New Brighton Road Bus Stop Improvements

Scheme Safety Audit

December 2020

2.1.3 Bus lane – Minor

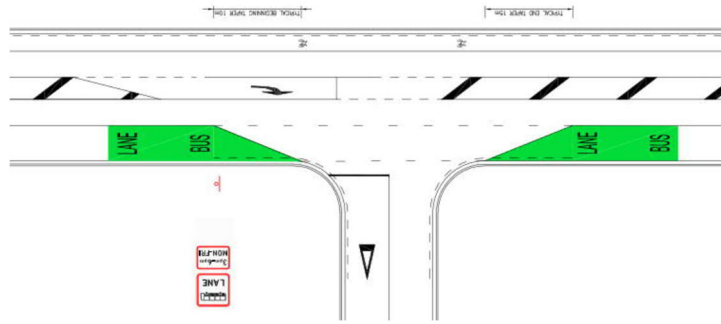
While on site the SAT noted the bus lane being used for the majority of its length from Marshland Road as a left turn lane by vehicles travelling east on New Brighton Road turning into The Palms shopping centre. This can result in conflict at the entranceway as the bus line marking is unclear.

Recommendations	Consider installing intersection markings to delineate start and end of bus lane around access way to shopping centre
Designers Response	Agreed. The Palm access is not a legal road but the intersection markings for bus lane could be added to highlight the access to approaching motorists.
Auditors Comment	No further comment.
Safety Engineer	Designer response noted and accepted
Clients Response	Responses noted and accepted
Action Completed	Yes

2.1.4 Vehicle tracking at entrance - Minor

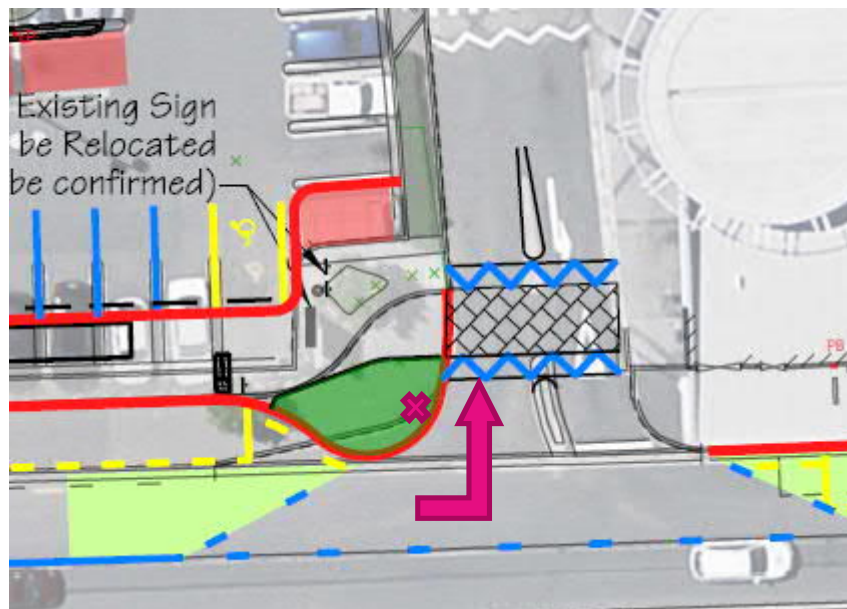
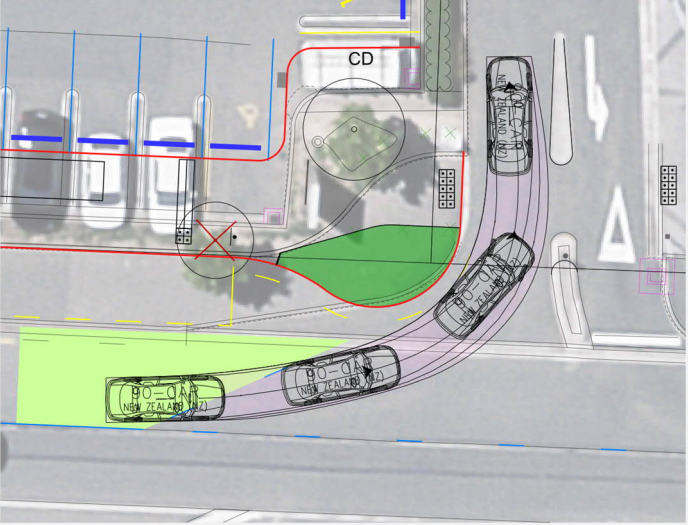
While on site the SAT noticed that vehicles often clip the kerb when entering The Palms. With the new buildout extending further out towards the road the likelihood of a vehicle clipping the kerb could increase.

It is acknowledge however that tracking has not been provided.

Recommendations	Confirm vehicle tracking is appropriate
Designers Response	<p>Noted. Vehicle tracking has been undertaken with 90 percentile NZ car turning into The Palms. The turning path shows that car is able to enter The Palms without mounting the kerb. The proposed kerb will be kerb only (CSS SD602) to deter motorists from mounting it and encourage motorists to slow down when entering The Palms access.</p> 
Auditors Comment	No further comment.
Safety Engineer	Designer response noted and accepted. New kerb alignment has more consistent radius, and requires drivers to take a higher entry angle, therefore less likely to clip kerb.
Clients Response	Responses noted and accepted
Action Completed	Yes, no further action required.

2.1.6 Parking dimensions – Comment

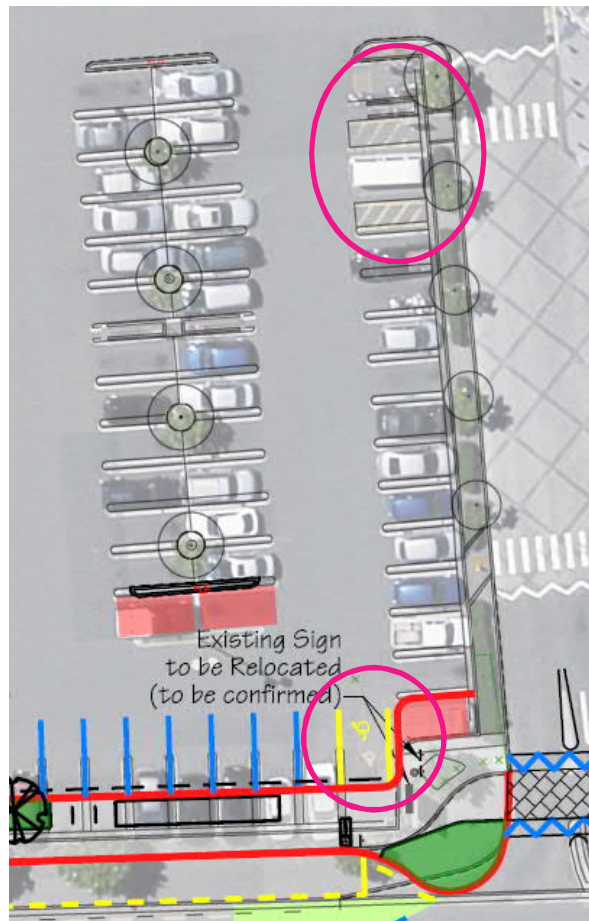
The SAT note that dimensions for the parking spaces have not been provided so cannot assess whether they are appropriate width and length. It is noted however that the mobility parking space provided does not match the existing mobility parks located within the car park

Recommendations	Consider providing extra width for safe entry and exit out of vehicle by matching the line marking of existing mobility parking.
Designers Response	Noted. The width of the proposed mobility parking is 3.6m wide (to the new kerb) and 5m long. This width meets the requirements for NZ Standards for mobility parking. The existing mobility parking space is 3.5m wide with 1.4m shared space more than the current requirements. We are unable to provide additional width to the proposed mobility parking to match existing without further loss of parking. We had a loss of six parking spaces with the current proposal. We proposed to mark the mobility parking with 2.5m stall width and 1.1 shared space to match the line marking of the existing mobility parking.
Auditors Comment	No further comment.
Safety Engineer	Designer response noted and accepted
Clients Response	Responses noted and accepted

2.1.7 Light pole – Comment

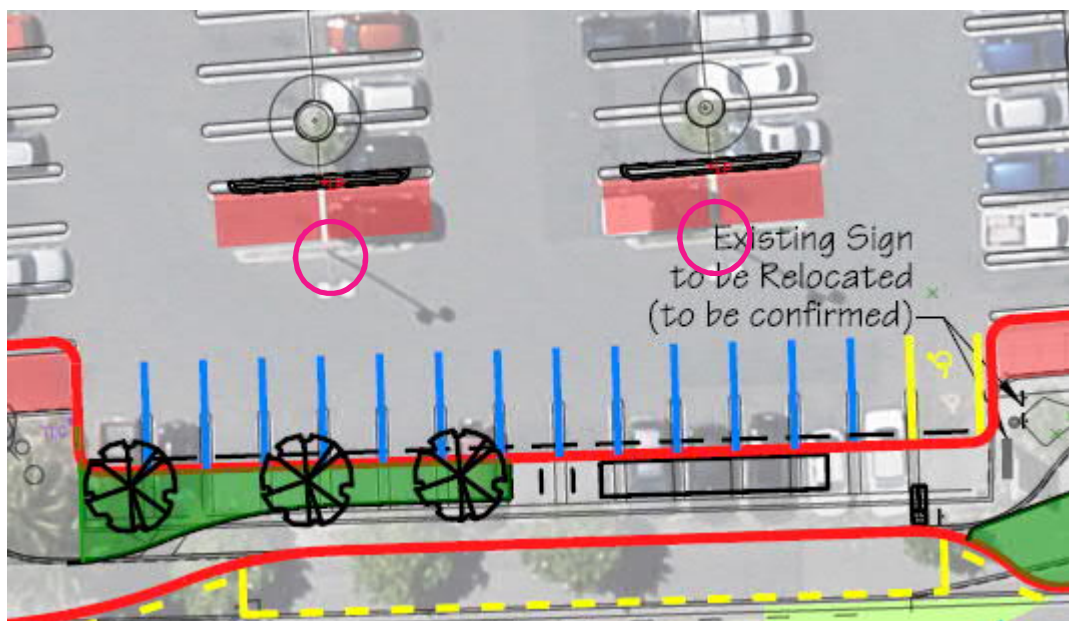
The SAT note that the existing light poles will have to be removed/relocated. It is assumed this will be picked up in detailed design / lighting plans.

Recommendations	Confirm relocation/removal of existing light poles
Designers Response	The two existing light poles are to be relocated. The lighting designer recommended to relocate them to maintain the lighting level in the carpark.
Auditors Comment	No further comment.
Safety Engineer	Designer response noted and accepted
Clients Response	Responses noted and accepted.
Action Completed	Yes, the relocation of lighting poles is to be included in detailed design
